ADDENDUM #1

Reference: Parleys Maintenance Station #234 Improvements
Utah Department of Transportation - Utah
DFCM Project No. 08211900

DFCM Project No.: 08211900
Archiplex Group Project No.: 0728.02

ADDENDUM NO. 1 to the Contract Documents for the Construction of UDOT Maintenance Station #2434, Parleys Canyon, Utah.

A1 | OCCUPANT FLOOR PLAN – LEVEL 1

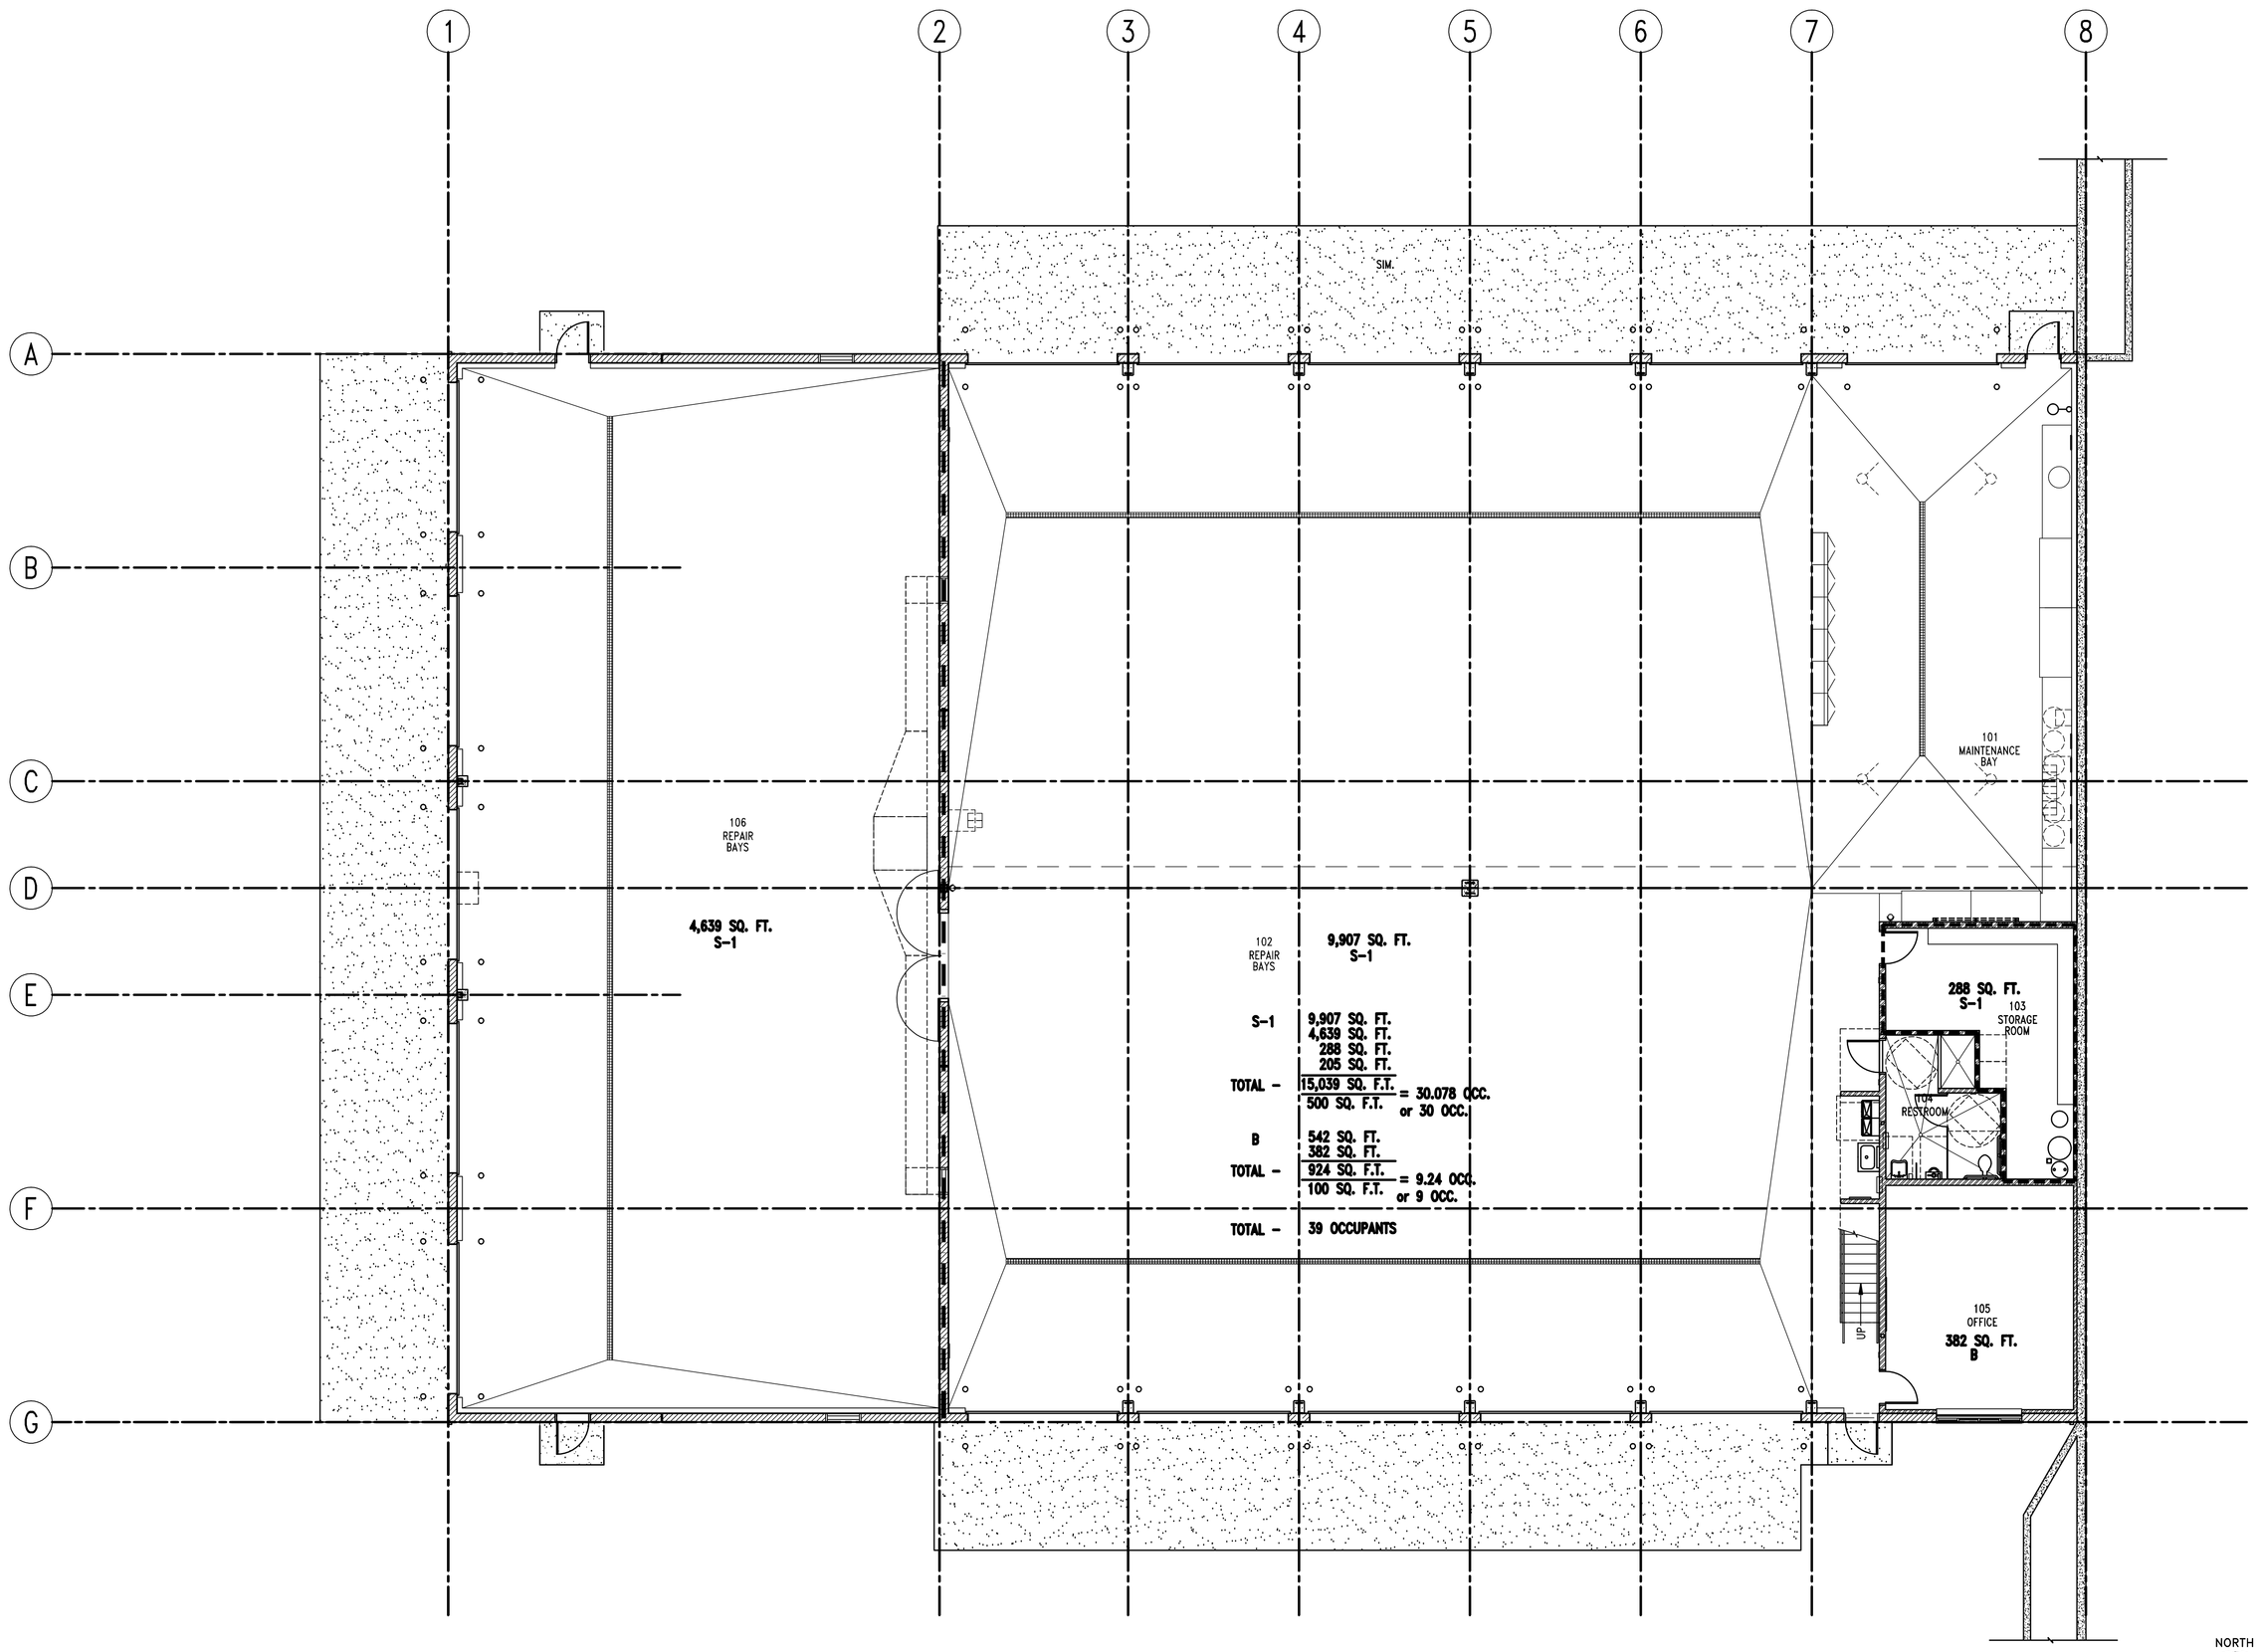
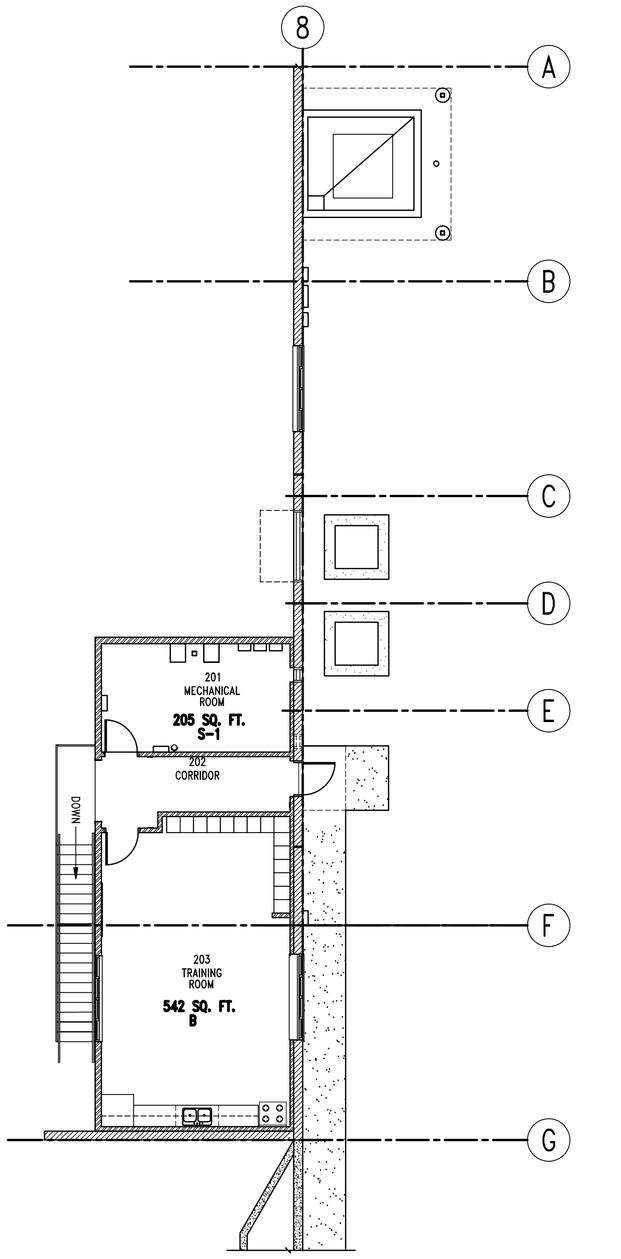
Sheet AE100:

a. Added Occupant floor plan as per Code Official request.

A1 | FLOOR PLAN - LEVEL 1

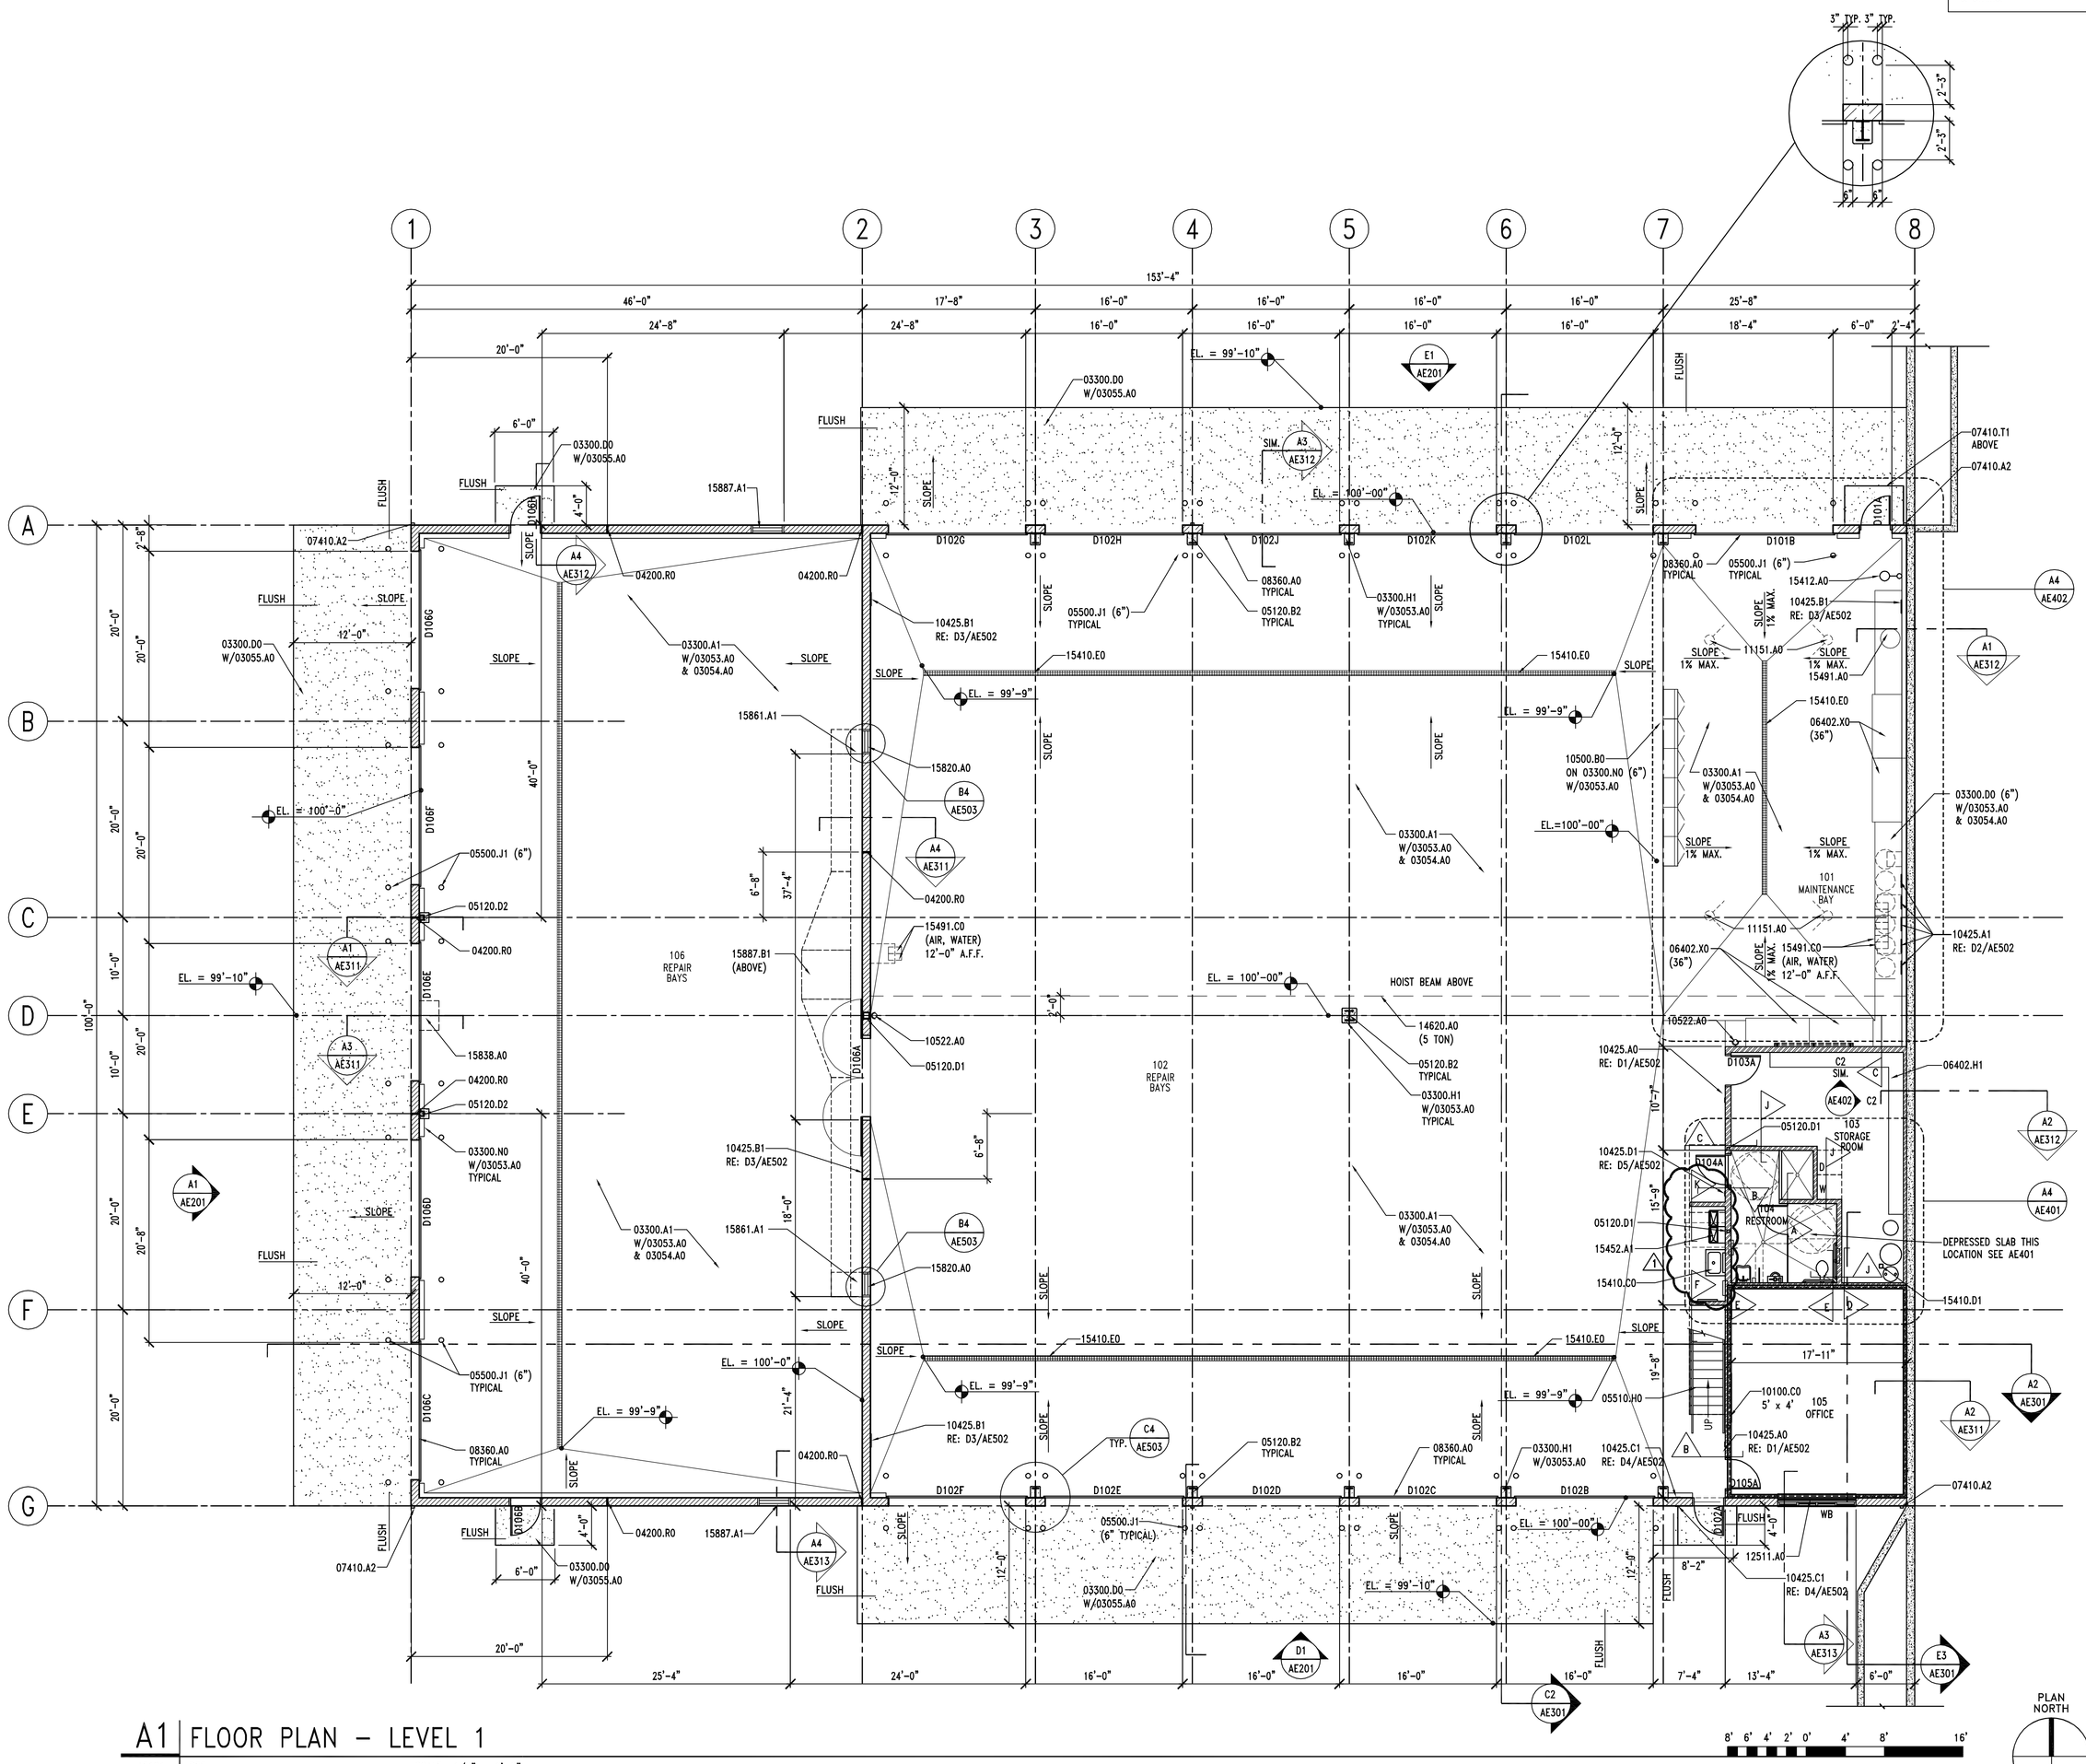
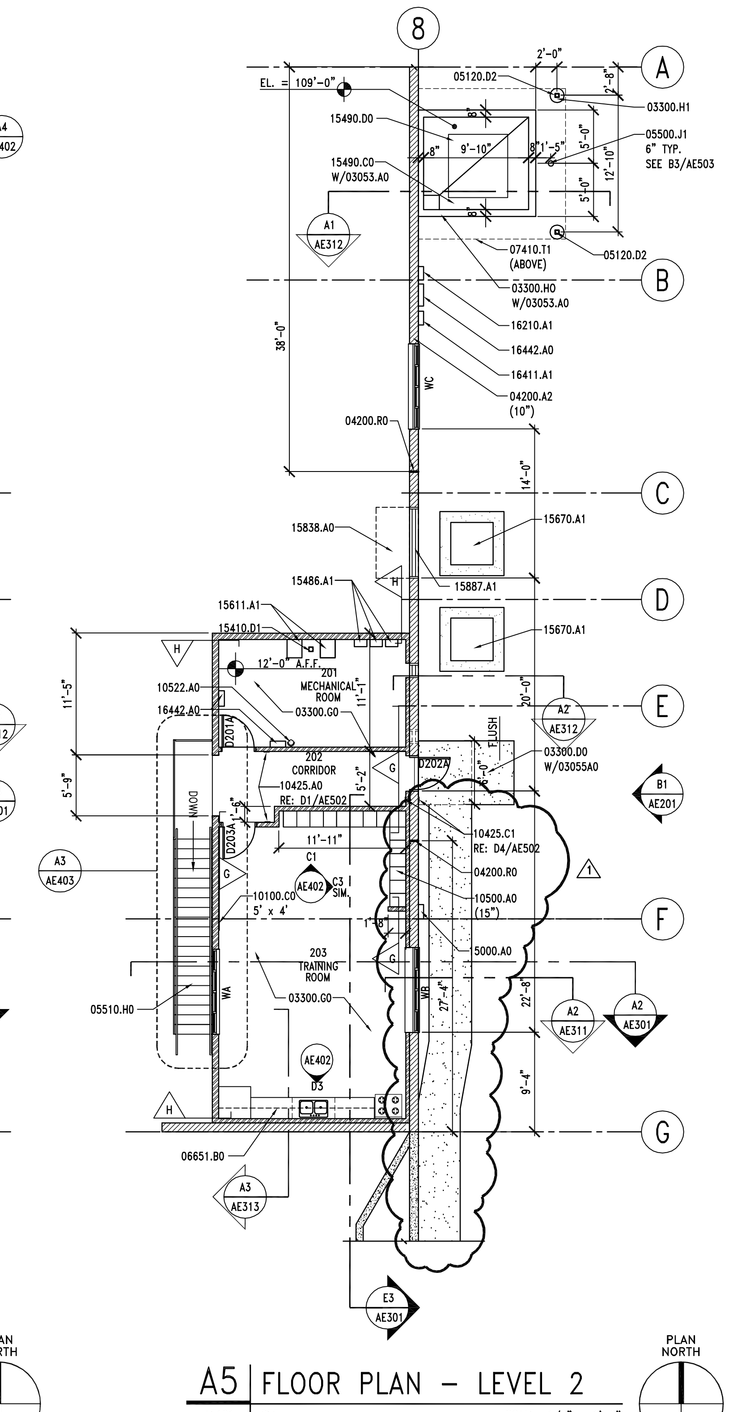
Sheet AE101:

a. Revised floor plan to show dual height drinking fountain with alcove.
b. Revised sidewalk at East side of building for Gas Meter clearances.
